**BELL BEND NUCLEAR POWER PLANT  
RESPONSE TO RAI Nos. 86 and 87  
BNP-2010-065      Docket No. 52-039**

Response to NRC Requests for Additional Information Nos. 86 and 87  
Bell Bend Nuclear Power Plant

Figure 13.1-3 {Hiring and Training Schedule for Plant Staff}<sup>1</sup>

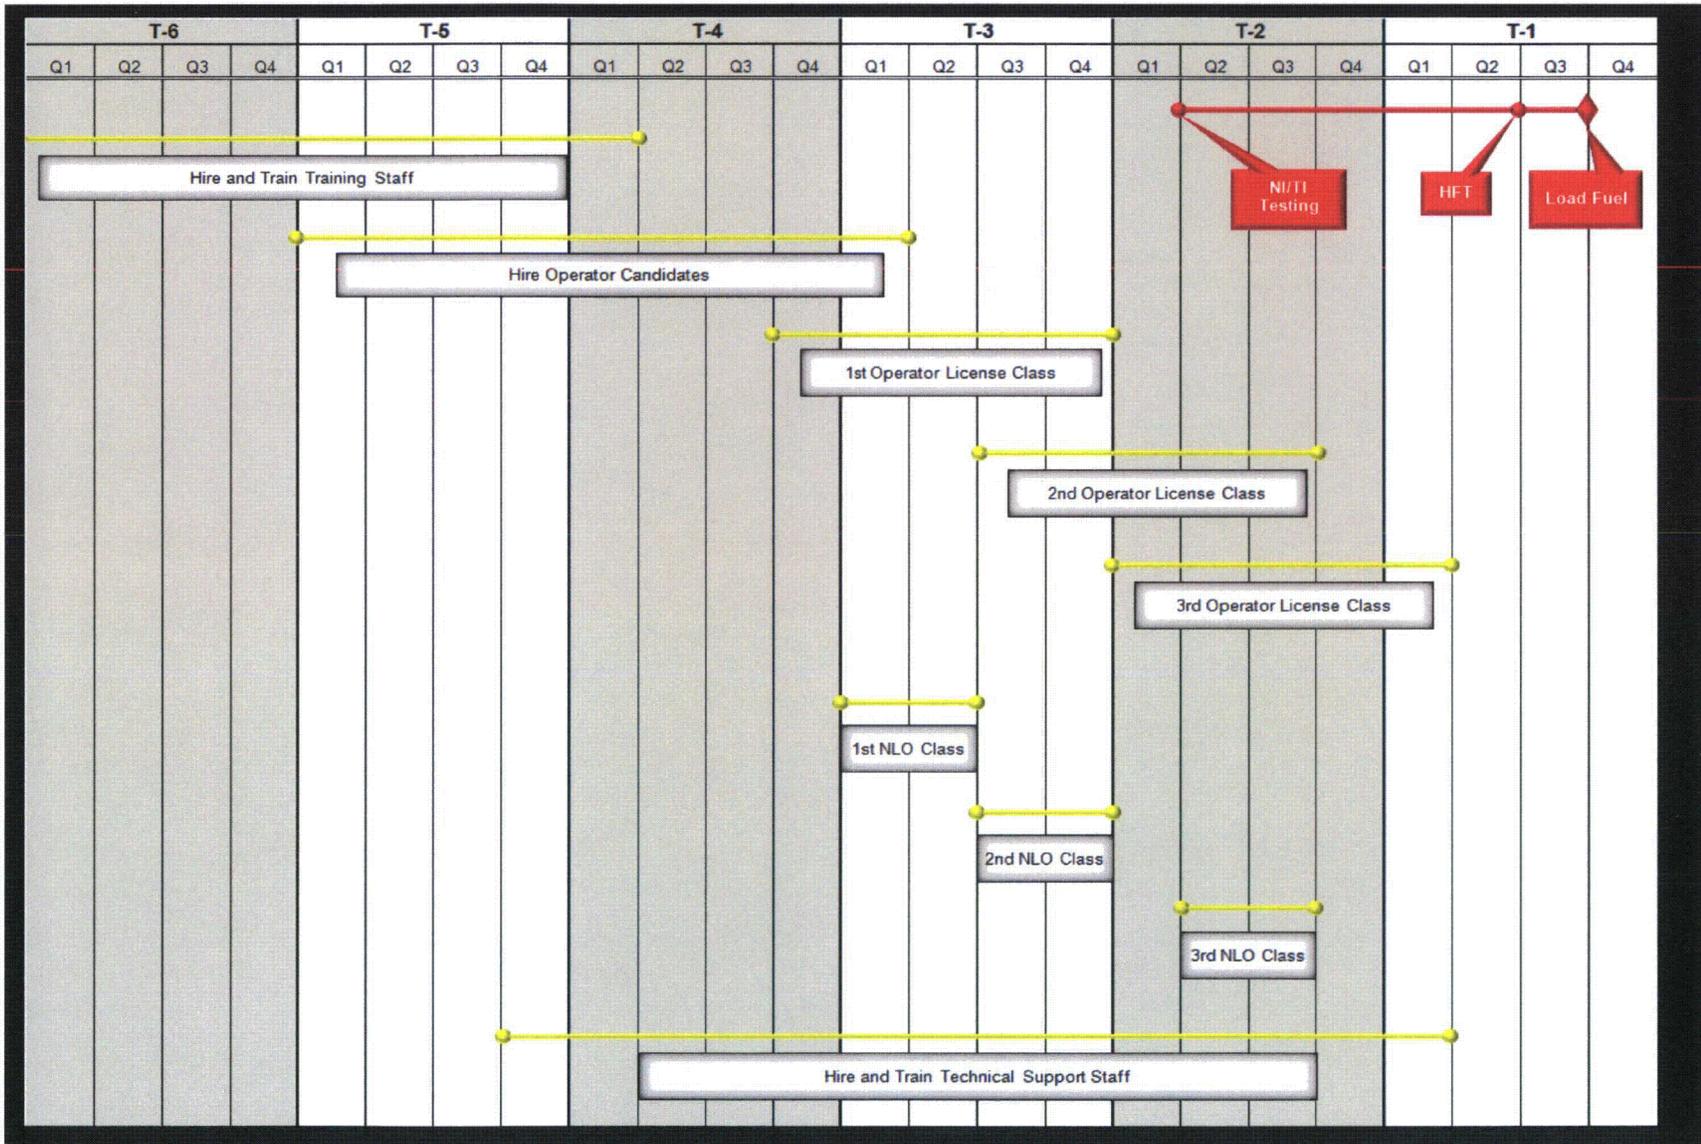
In accordance with NUREG-0800 (SRP), Section 13.1.1 I.1.B.ii, a description of the development and implementation of the applicant's staff recruiting and training programs should be included in the application as part of the management organization for the initial test program.

Please indicate where this information could be located in the application.

Staff recruiting is part of the hiring process illustrated in Figure 13.1-3, Hiring and Training Schedule for Plant Staff, which will be added to FSAR Section 13.1. PPL Bell Bend will add information describing the development and implementation of the BBNPP training program to the BBNPP COLA.

Figure 13.1-3, shown below, will be added to FSAR Section 13.1

Figure 13.1-3 {Hiring and Training Schedule for Plant Staff}<sup>1</sup>

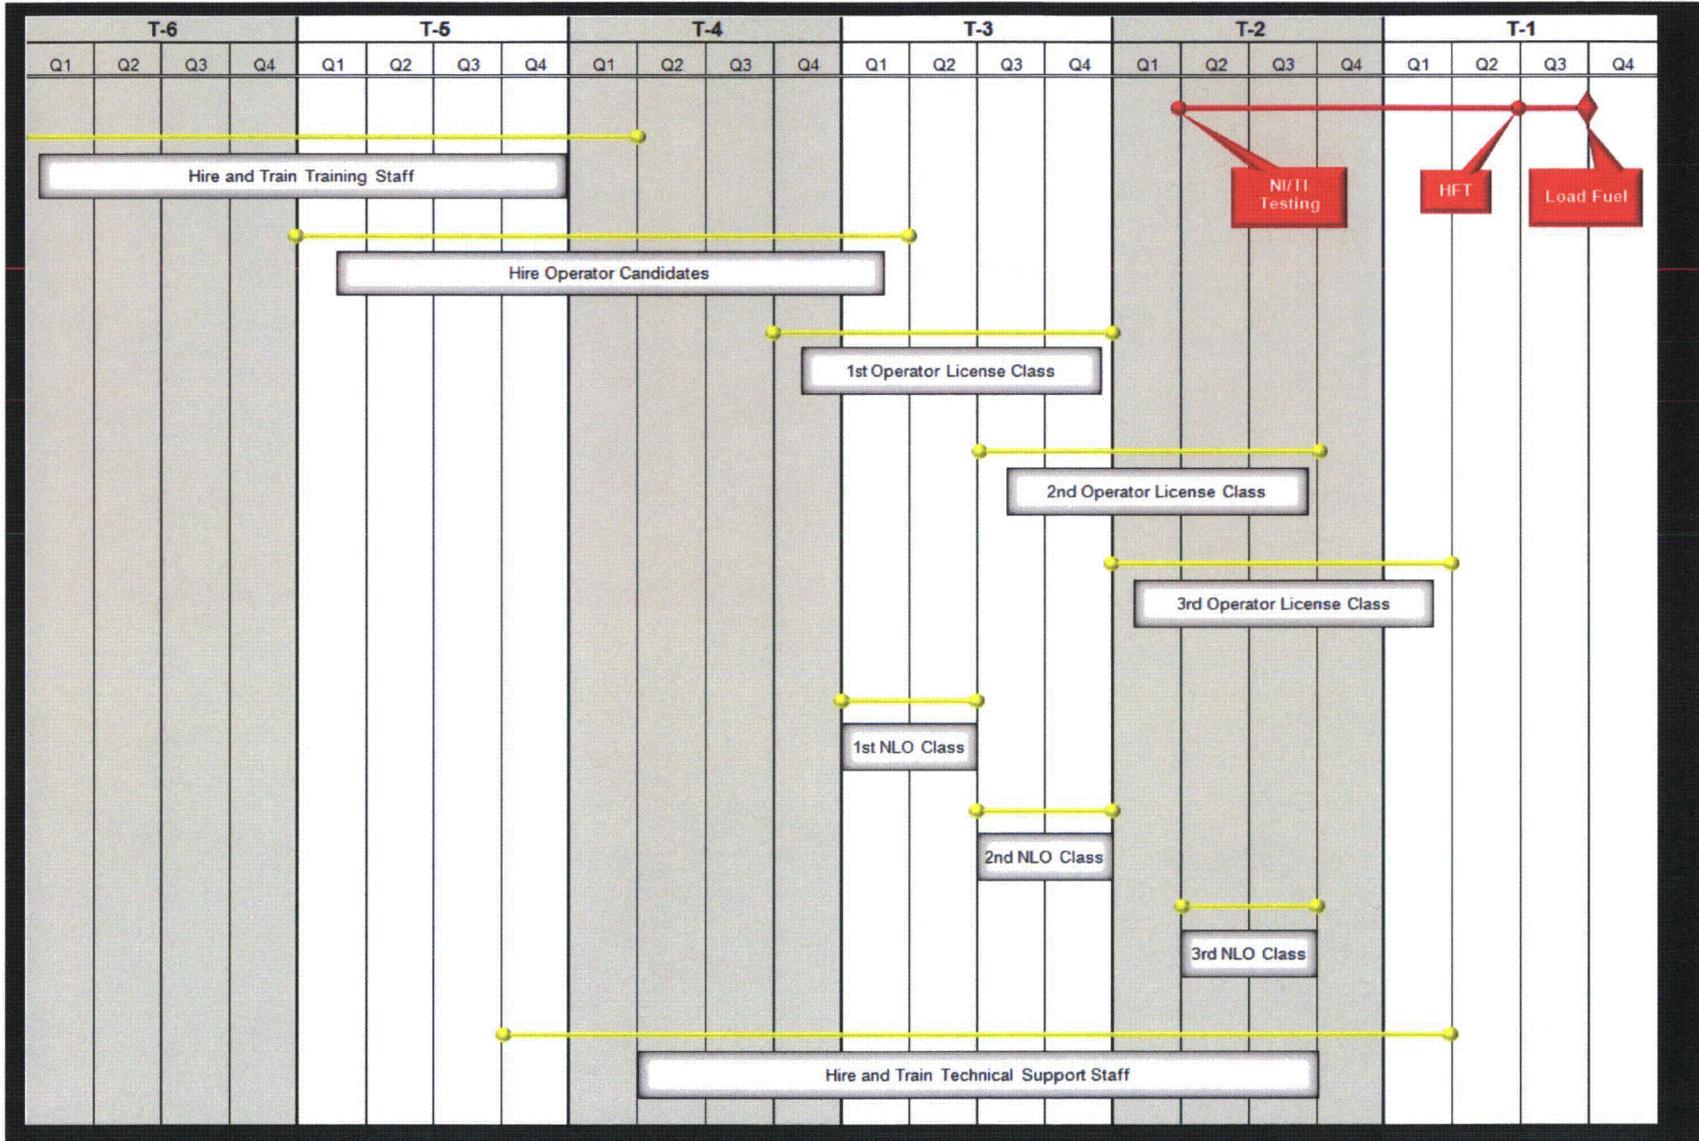
In accordance with NUREG-0800 (SRP), Section 13.1.2 – 13.1.3, “Operating Organization,” Section I.1.G, a schedule relative to fuel loading for each unit for filling all positions should be included in the application. FSAR sections 13.1.1, 13.1.1.2, and 13.1.2 state that “the schedule for filling key organization positions is provided in Table 13.1-1.”

Please indicate where in Table 13.1-1 this information could be located.

FSAR Table 13.1-1, “BBNPP Position/Site Specific Position Cross Reference,” includes four columns labeled: “Design Review Phase,” “Construction Phase,” “Pre-op Phase,” and “Operational Phase,” which are high level schedule milestones and list the functions, titles, and staffing for the milestones. BBNPP will update the title and number of non-licensed operators to reflect shift staffing plans and add a more detailed hiring and training schedule for plant staff in FSAR Section 13.1.

An estimate of the number of persons to be assigned to various groups, and the schedule for filling the corporate and operating organization positions are provided in Table 13.1-1 and are shown in Figure 13.1-3. To support these personnel in the performance of their duties and responsibilities, PPL Bell Bend, LLC will develop and implement the appropriate training programs in a timely manner such that personnel receive the required training prior to performing their assigned duties. The training program is described in Section 13.2.

Figure 13.1-3, shown below, will be added to FSAR Section 13.1

Figure 13.1-2 {Bell Bend Nuclear Power Plant Operating Shift Organization}<sup>1,2</sup>

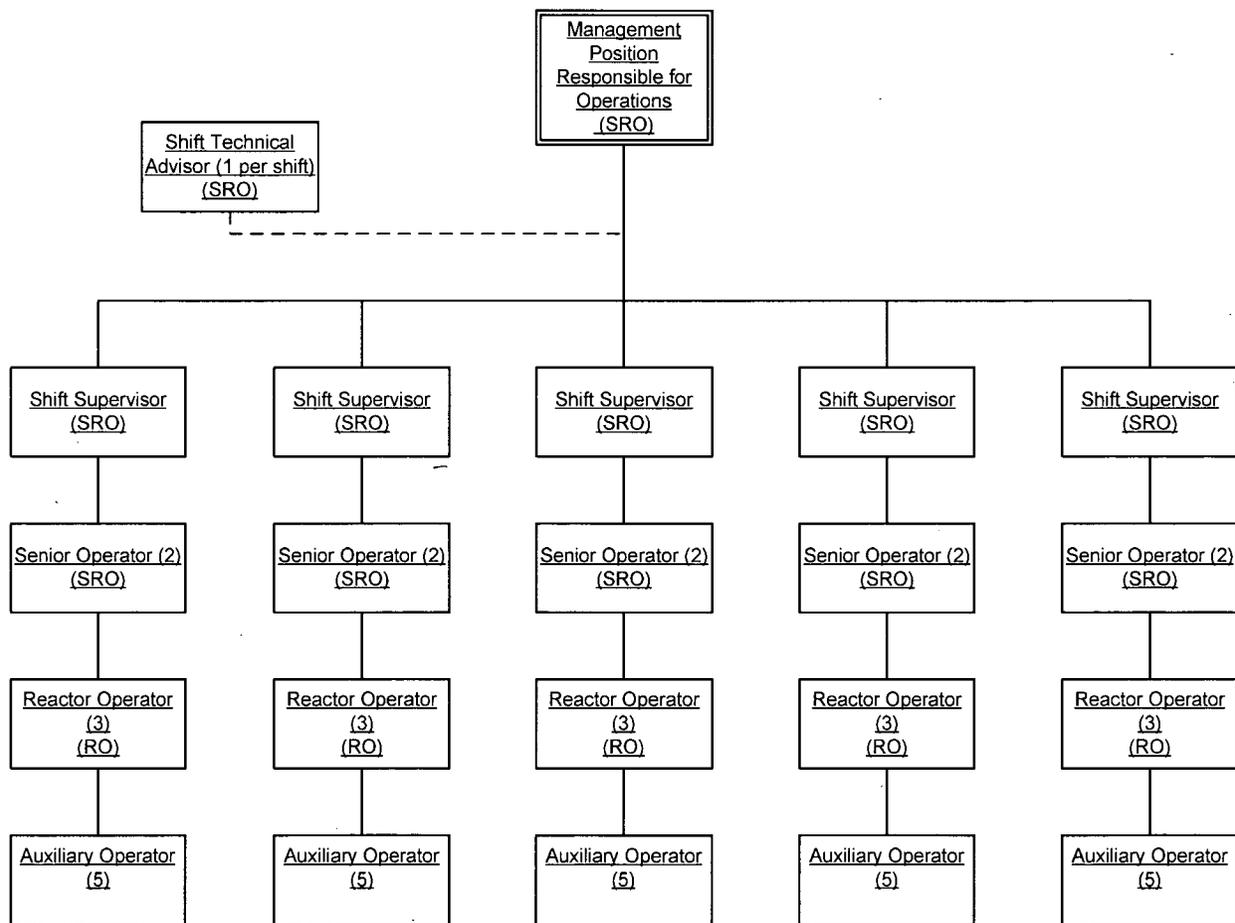
In accordance with NUREG-0800 (SRP), Section 13.1.2 - 13.13, "Operating Organization," Section I.2.A, the application should include an organization chart with the title of each position, the minimum number of persons to be assigned to duplicated positions, the number of operating shift crews, and the positions for which reactor operator and senior reactor operator licenses are required.

Please indicate where this information could be located in the application.

The FSAR will be revised to add a diagram of the BBNPP Operating Organization illustrating the title of each position, lines of responsibility, number of personnel, and license requirements for shift staffing to the BBNPP COLA.

The shift manning for the unit will be a five shift rotation, with one shift dedicated to training at any given time. Table 13.1-2 defines the position titles, license requirements and minimum shift manning for various modes of operation. Figure 13.1-2 illustrates the operating shift organization. The operating shift staffing meets or exceeds the requirements of NUREG-0737, Action Plan Items I.A.1.1 and I.A.1.3 (NRC, 1980), 10 CFR 50.54(m) (CFR, 2008), and the NRC's "Policy Statement on Engineering Expertise on Shift" (NRC, 1986)
